GROUP 51

EXTERIOR

OUTLINE OF CHANGES

Wiper and Washer Switch Continuity Check

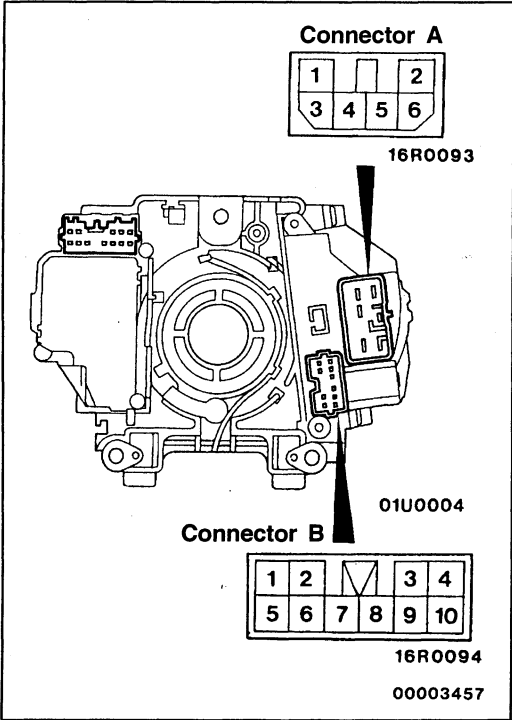
- The inspections of wiper and washer switch and headlamp washer switch have been changed to correspond to the change of the column switch.

Switch position		Terminal No.				
		6	7	8	9	10
Wiper switch	OFF		○—○			
	INT		○—○			
	1 (LO)			○—○		
	2 (HI)				○—○	
Washer switch	ON	○				○
